## Product/Process Change Notice (PCN)

PCN #: WL-SIMW\_20171215

WL-SIMW 154353xxx all products

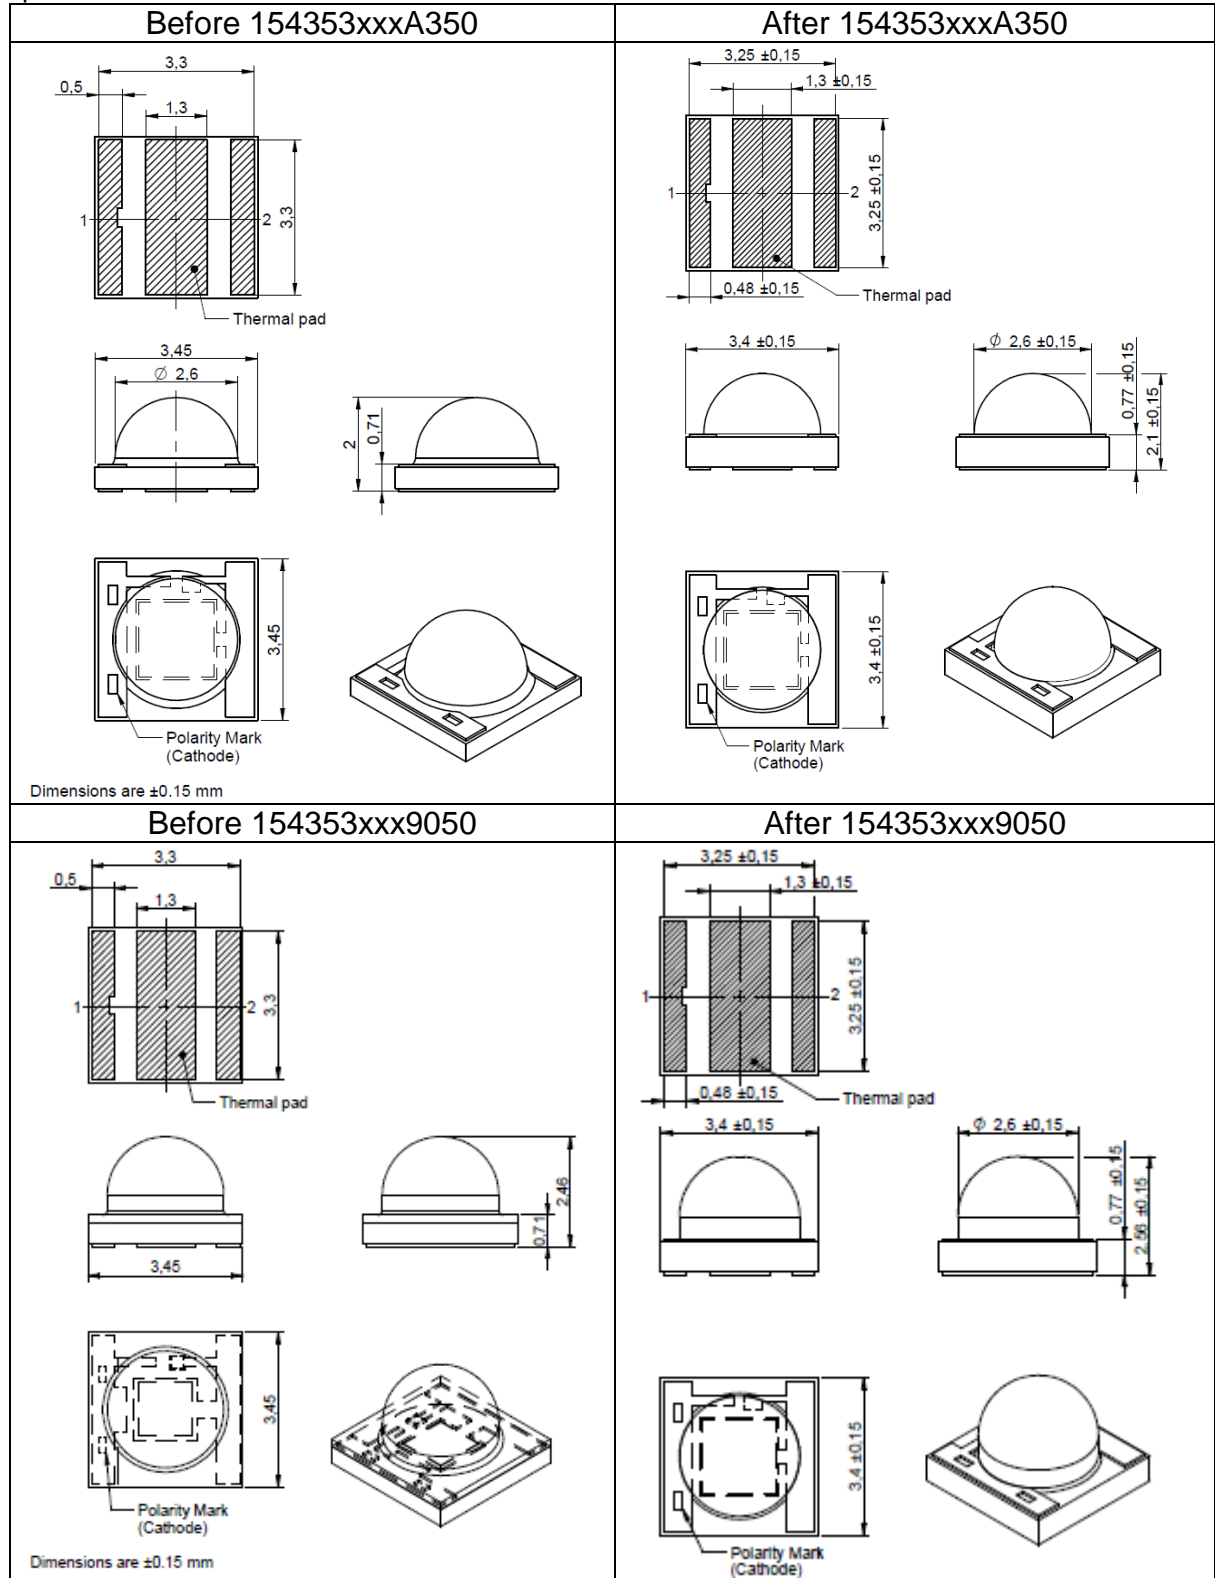
For process improvement purposes, Würth Elektronik will change the dimensions of the substrate for the WL-SIMW line products with 0.05mm

The substrate size will be the only change. The change will not affect the land pattern and soldering specification.
